2.0 THERMAL-HYDRAULIC ANALYSIS

F/12

October 6, 2000 (2:57PM)
 air cooled case includes heat added from oxidation while the adiabatic case does not. In the early year after shutdown air cooling is not effective...
 → additional heat source overgoes

2.1
Figure 1: PWR heatup times for air cooling and adiabatic heatup.

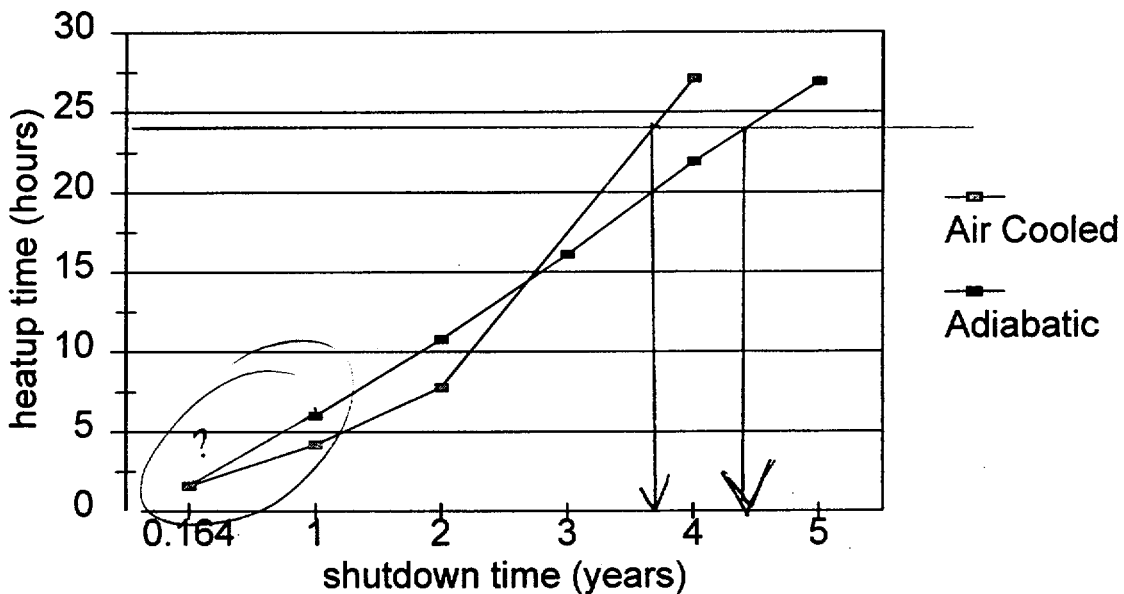
decay heat rate (after complete fuel uncover)

without any recovery actions the heat rate

This is due to the modeling of the fact that the adiabatic heating

2.2
Figure 2: Heatup time from 30 C to 800 C

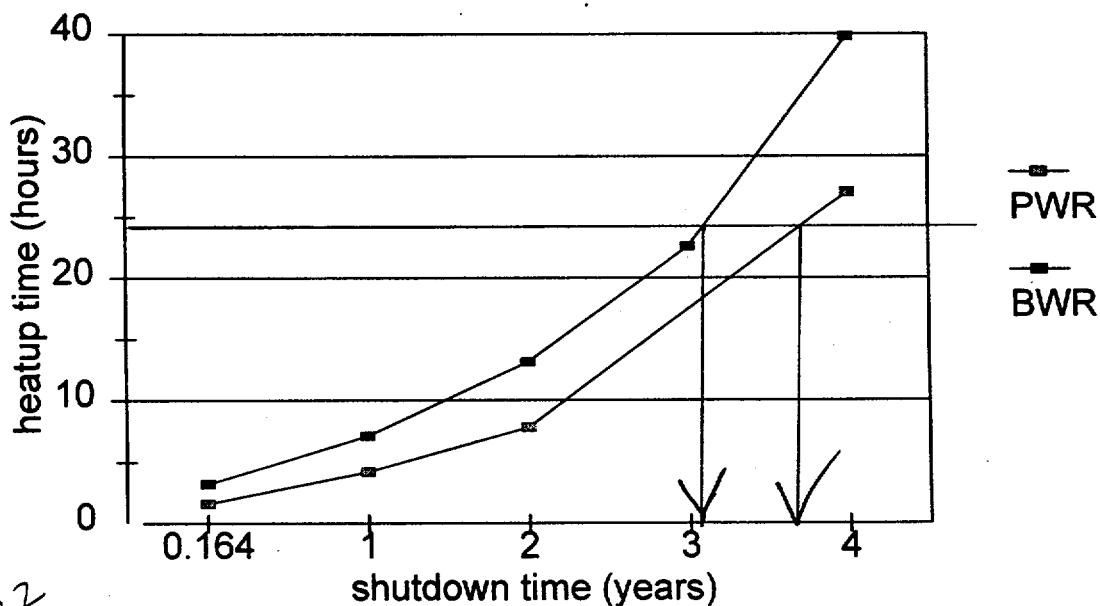
if no recovery
actions are
taken

Need a paragraph which makes clear
the important variables and why a definitive
generic "no fire" number is NOT
feasible.

Do we need any research in
this area?
